JLG 24146.01-5 Dunn County Public Safety Center

Issued: November 4, 2025

ADDENDUM #: 01

7A
A802 FFE PLAN - LEVEL 1
SCALE: 1/8" = 1'-0"

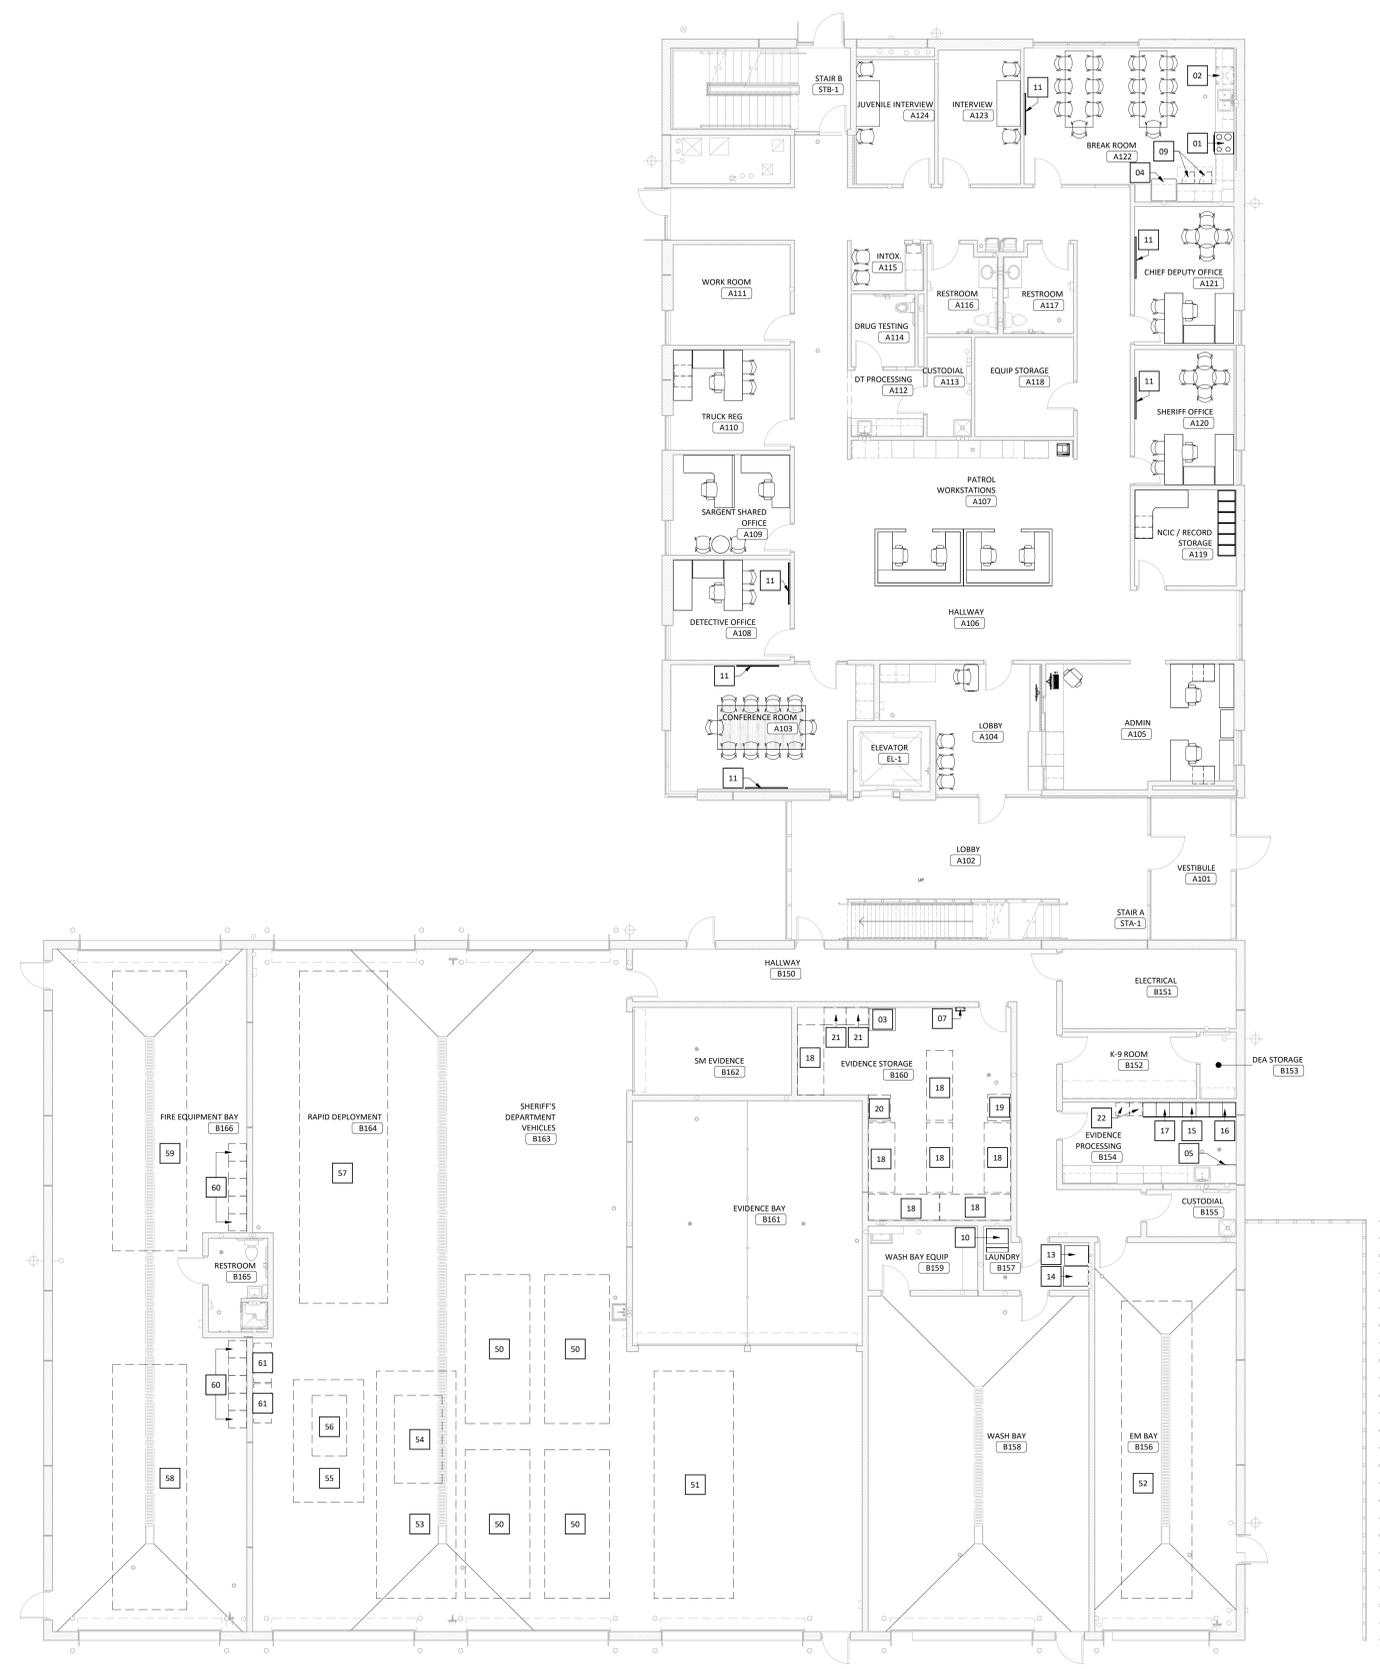
- Replace sheet in its entirety.
 - Equipment Schedule: schedule was updated with to show responsibilities.
 - Drawing 7A: Additional equipment tags were added to items that were not tagged yet.

3 PLUMBING PLAN - ENLARGED MECHANICAL ROOM
1/8" = 1'-0"

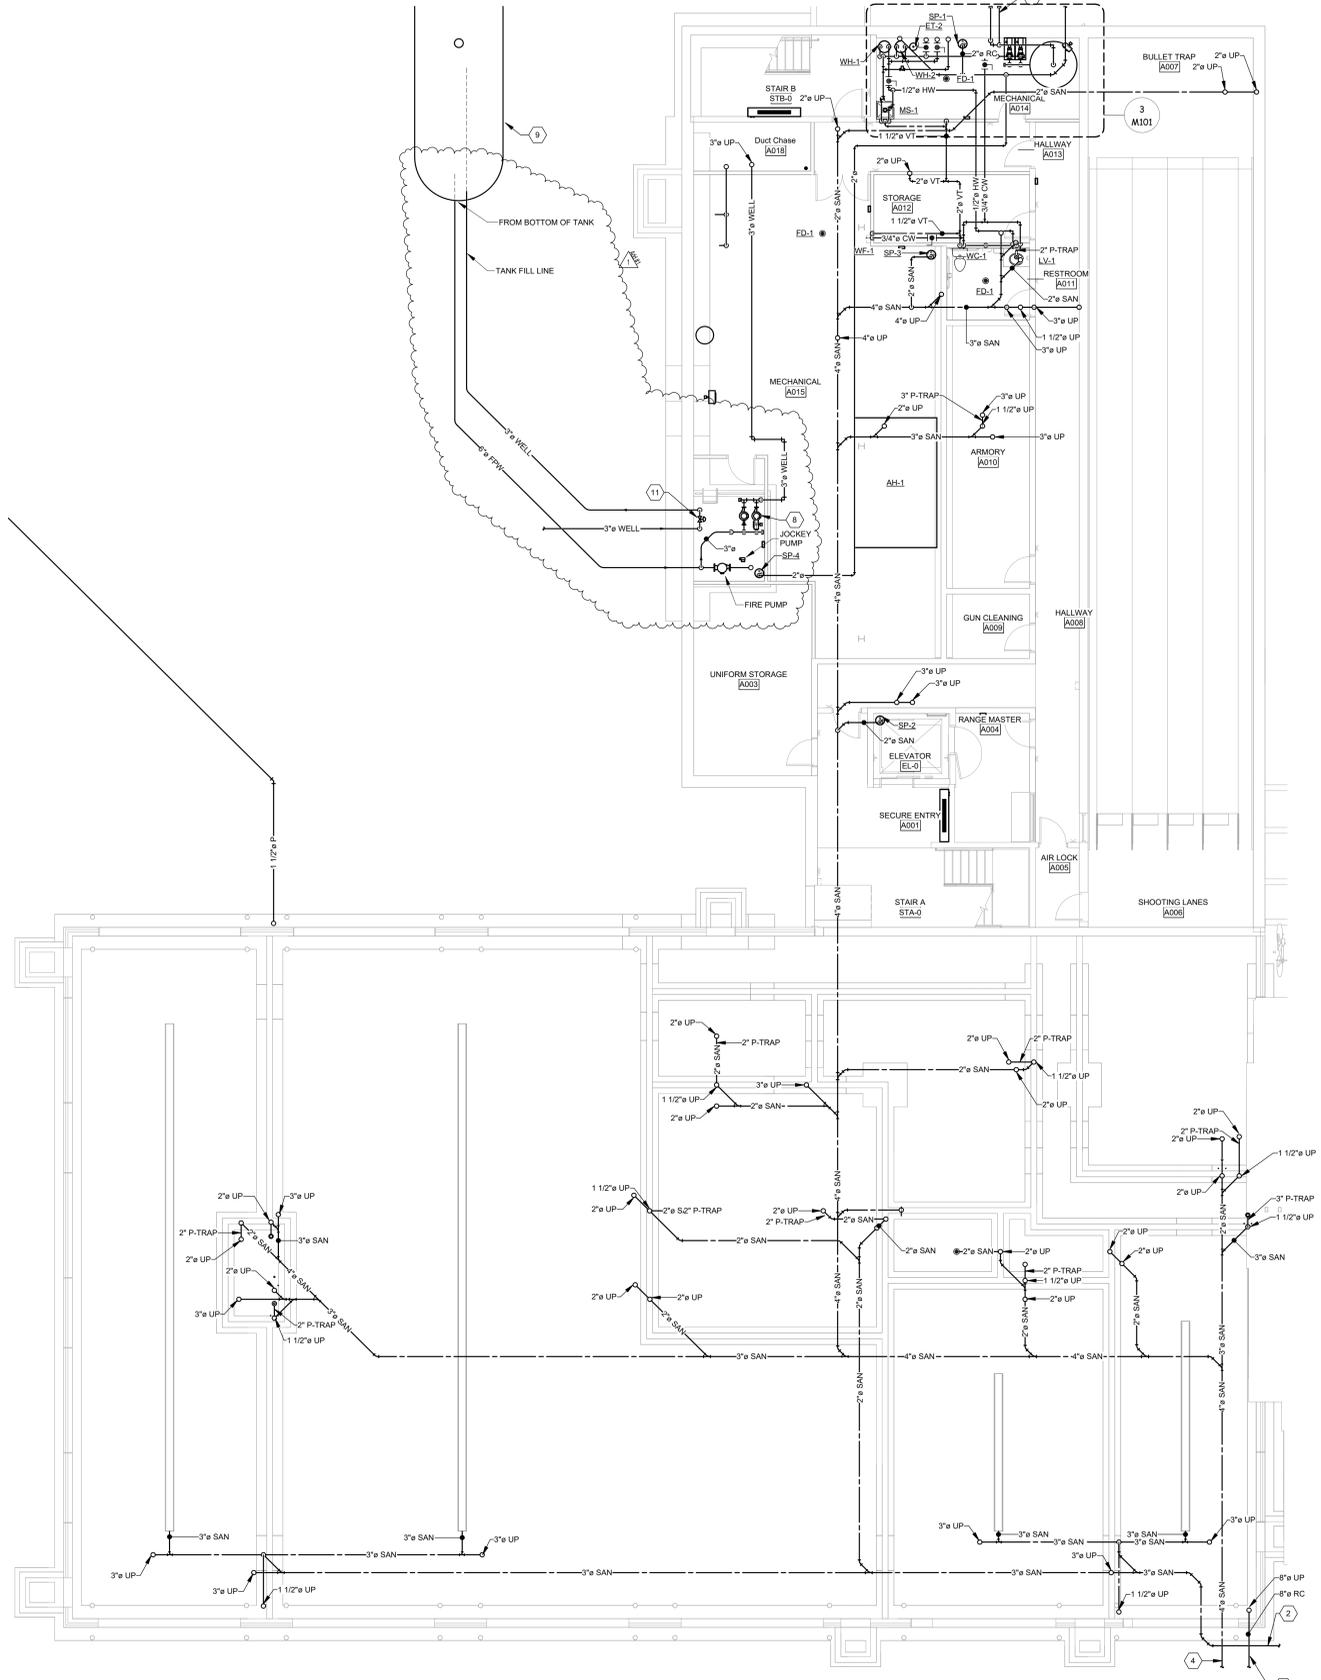
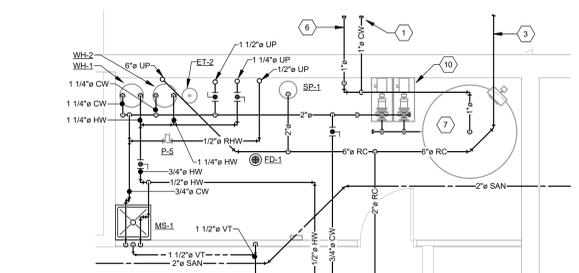
- 1. M101 – PLUMBING PLANS
 - o Note 6: Provide 1" water to irrigation in lieu of 1-1/2".
 - o 1/M101:
 - Reconfigured layout for fire pump pit/room.
 - o 3/M101:
 - 1" water service in lieu of 2".
 - Pipe water service to storage tank. Pipe building water from tank to pump.

1 PLUMBING PLAN - LEVEL 1
1/8" = 1'-0"

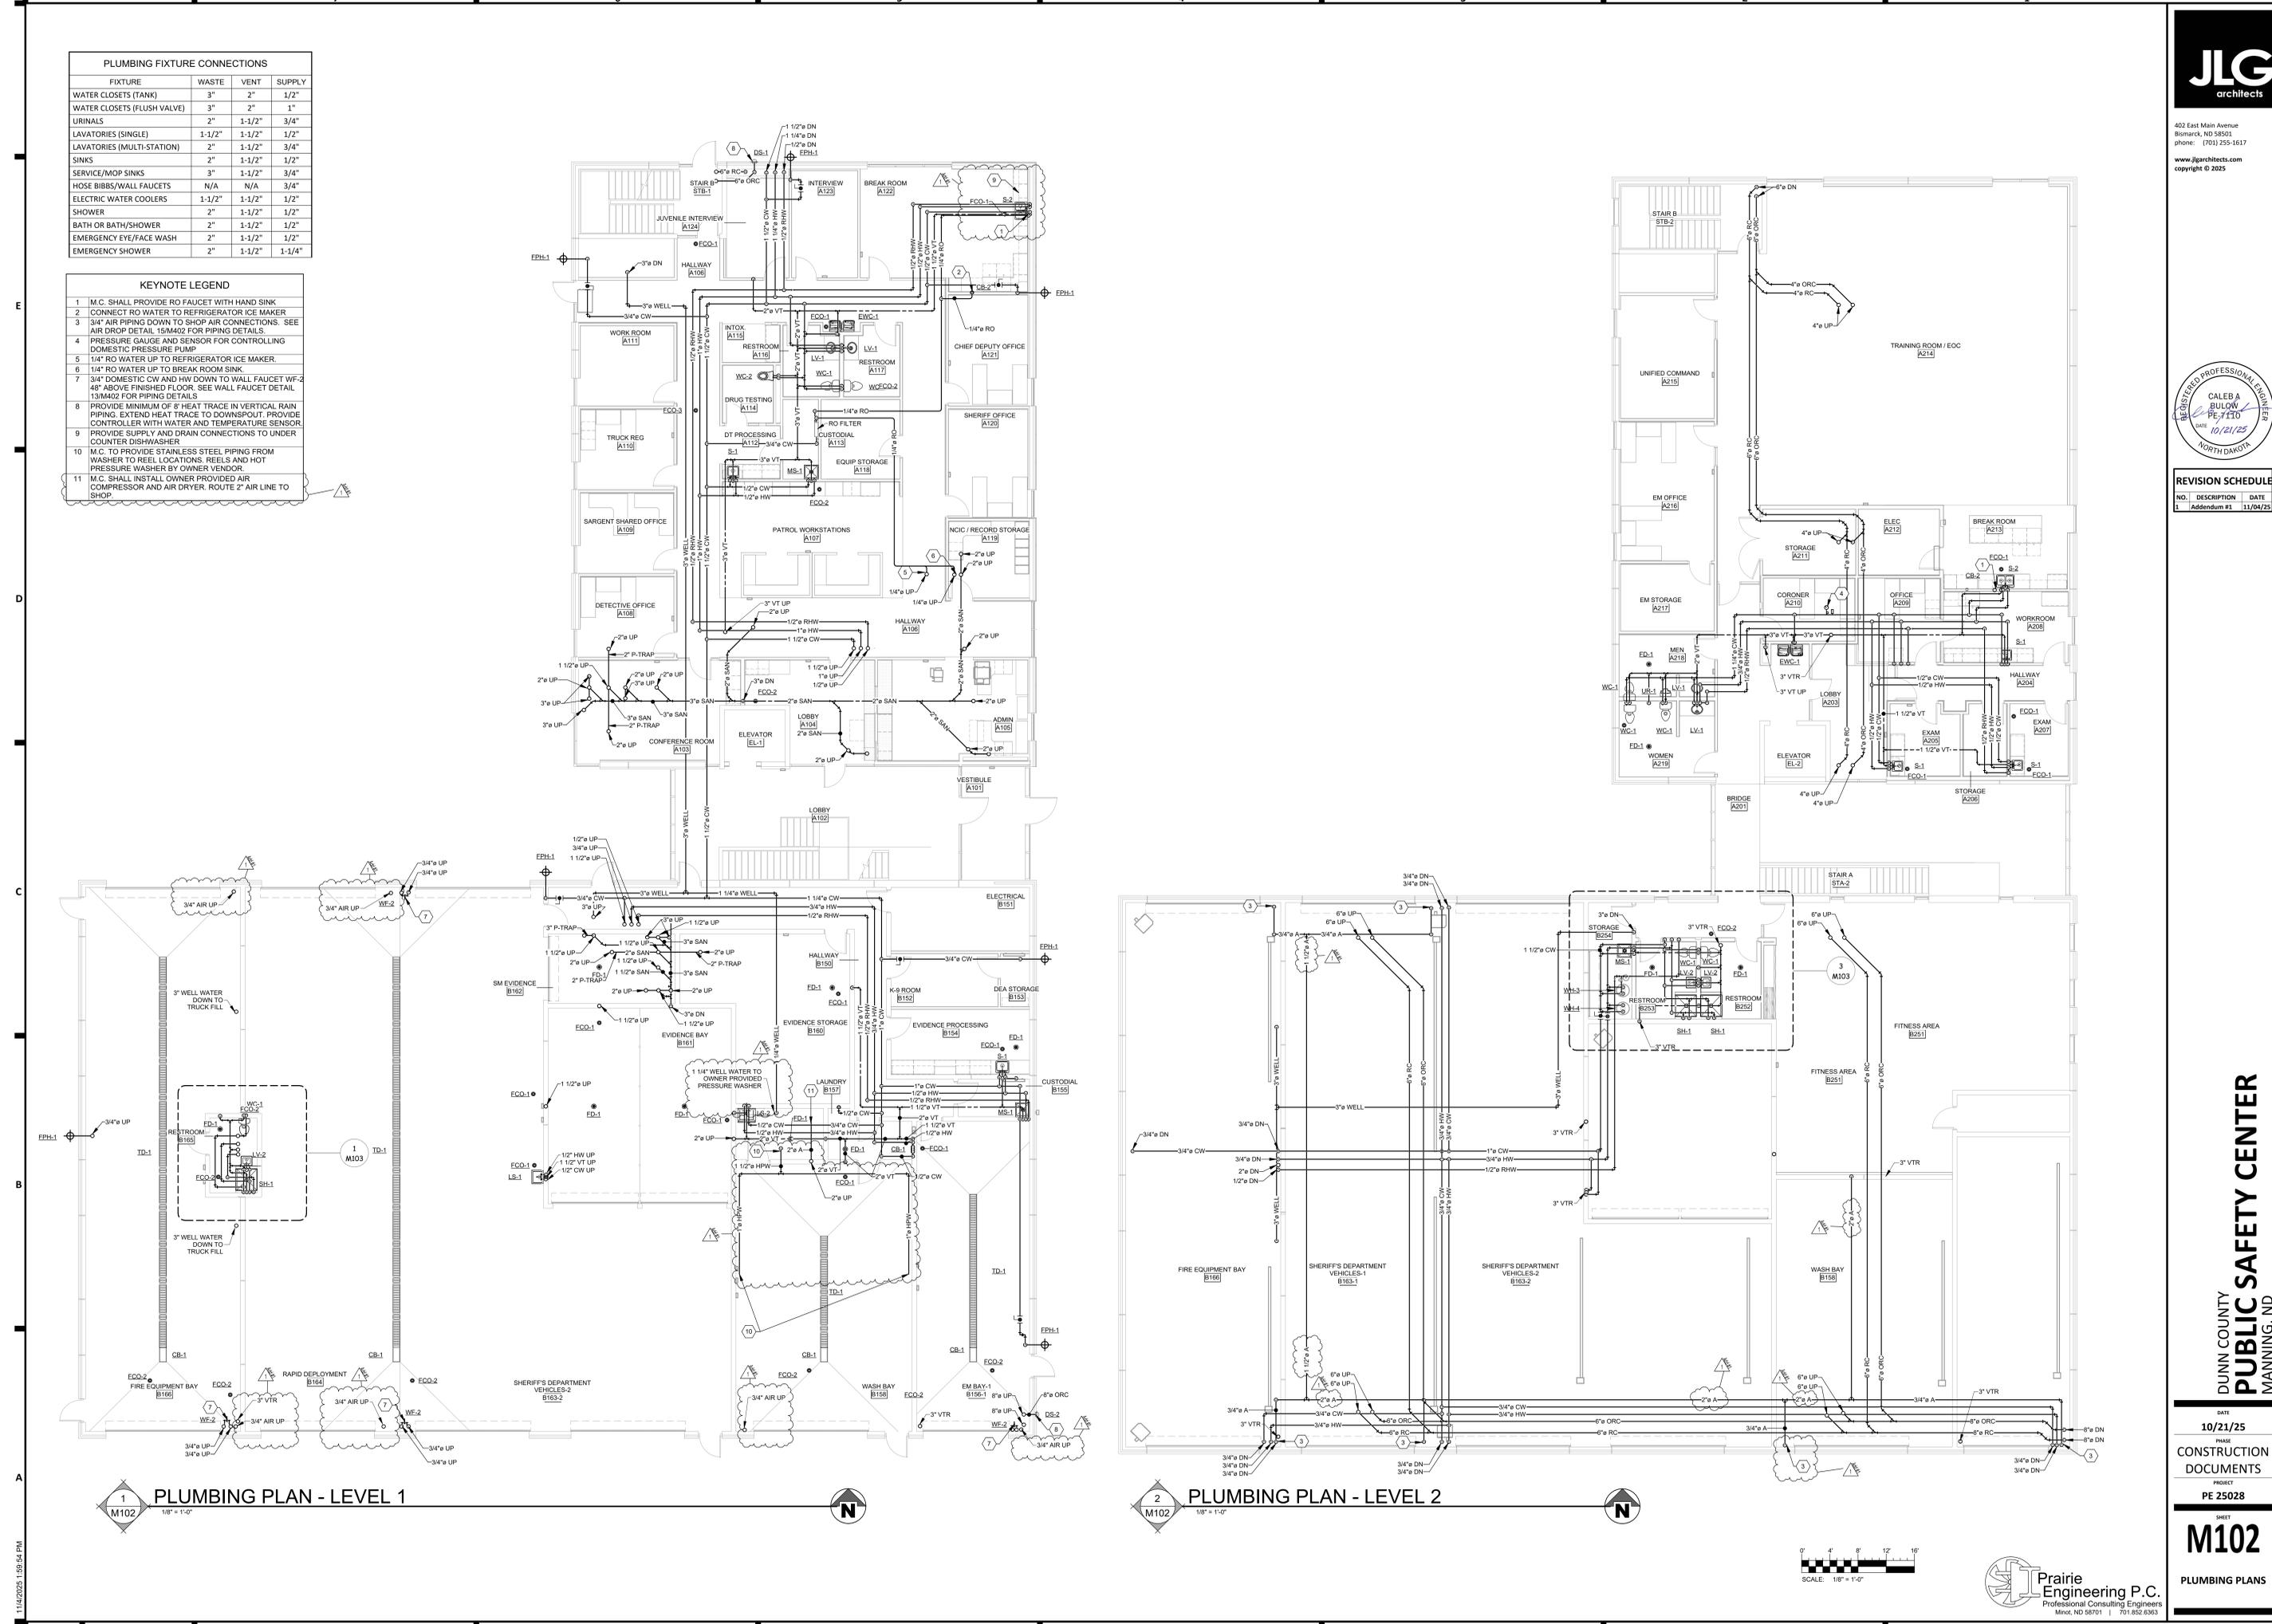
2. M102 – PLUMBING PLANS
 - Note 11:
 - Reworded note to remove aluminum requirement
 - 1/M102:
 - Changed break room sink to two compartments.
 - Increased pipe size for main air trunk from air compressor to 2"

- Reconfigured and resized water from pressure washer
 - Added tag for well water supplying pressure washer
 - Modified tags for air drops to better indicate pipe type.

1 HVAC PLAN - LEVEL 2
M302 1/8" = 1'-0"

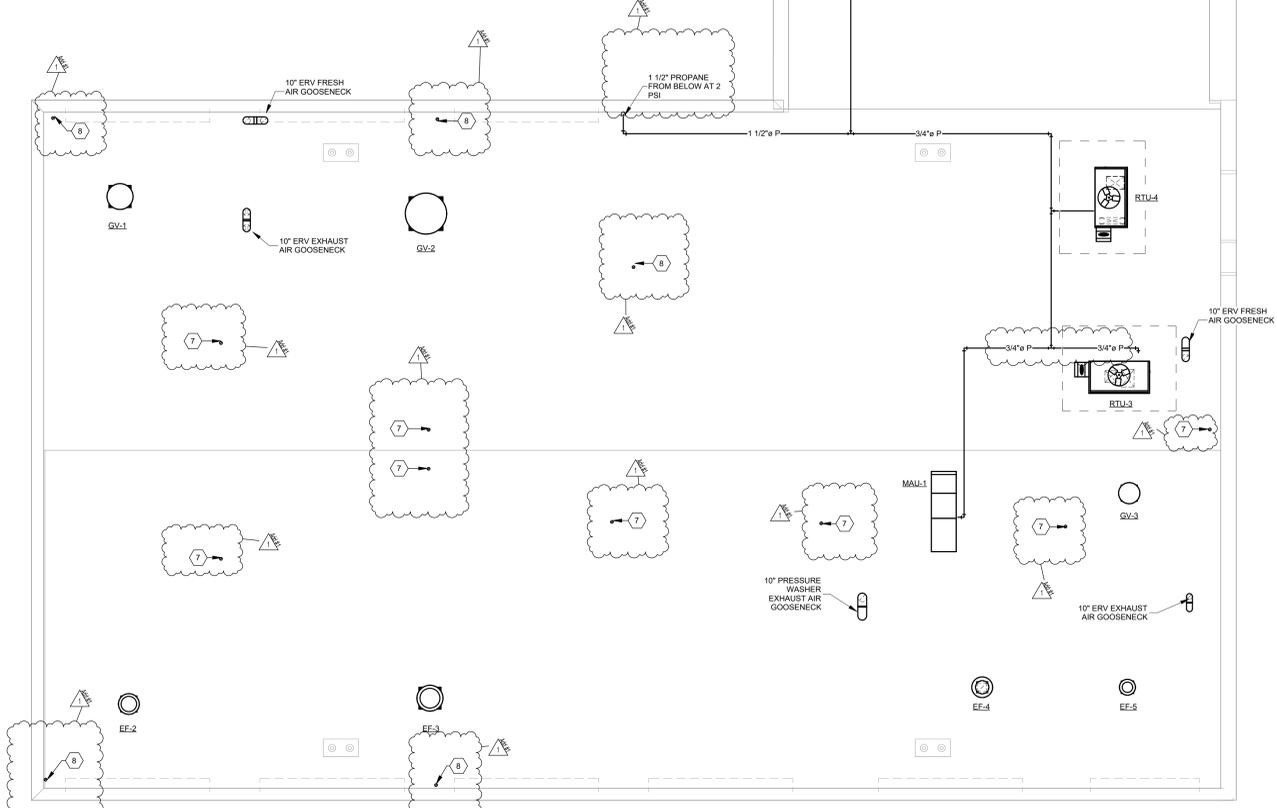
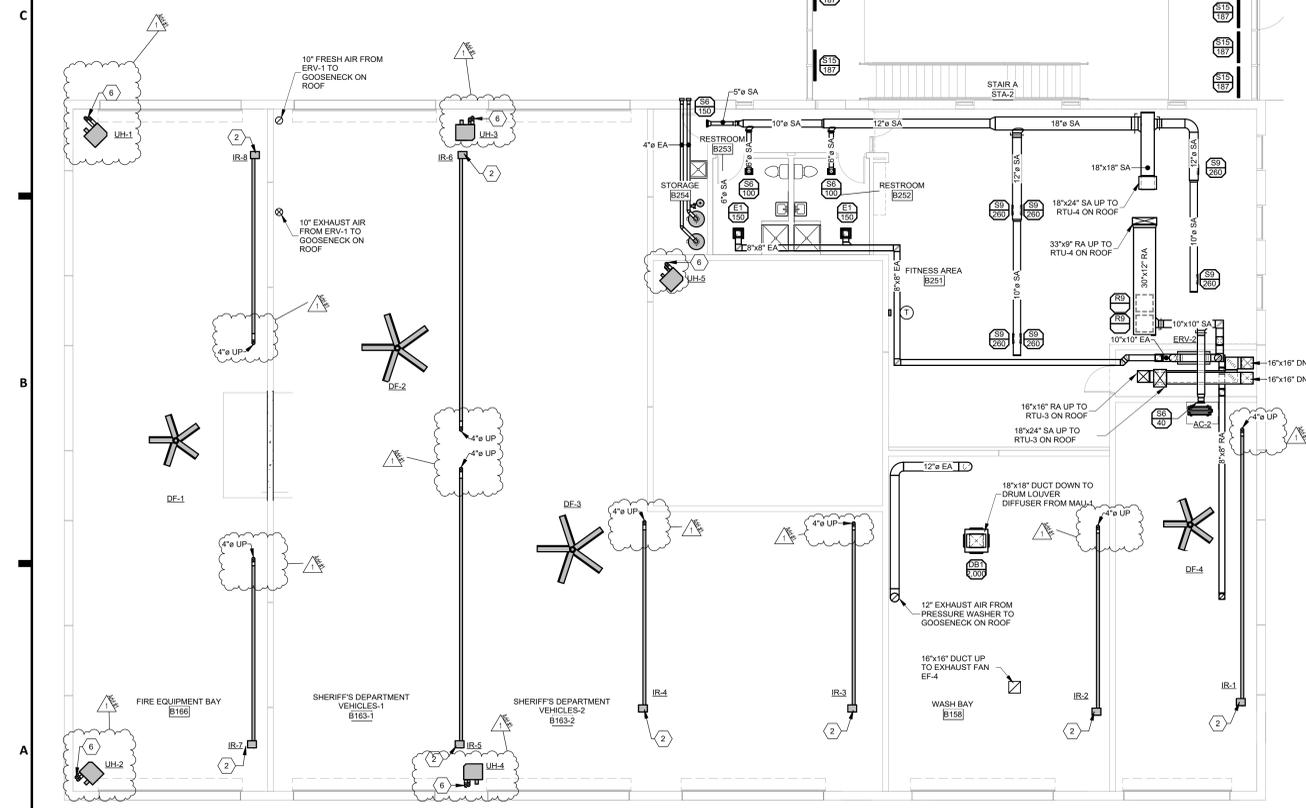
- DRAWING 1/M302:
 - Added exhaust and venting for unit heaters and infrared heaters
 - Drawing 2/M302:
 - Added exhaust and venting for unit heaters and infrared heaters

9 M401 NTS
WATER SERVICE DETAIL

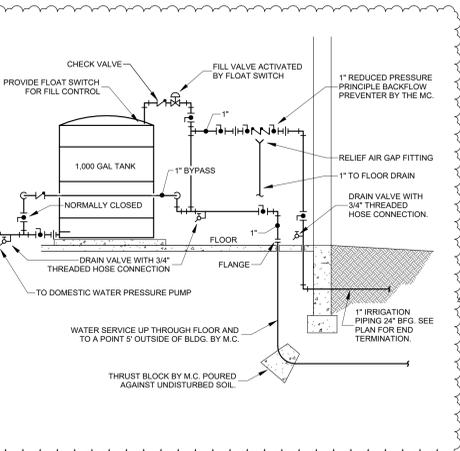
8. M401 – MECHANICAL DETAILS
 - Drawing 9/M401: Omit water meter. Will be installed by others in exterior meter pit. Utility pipe shall be 1" in lieu of 2".
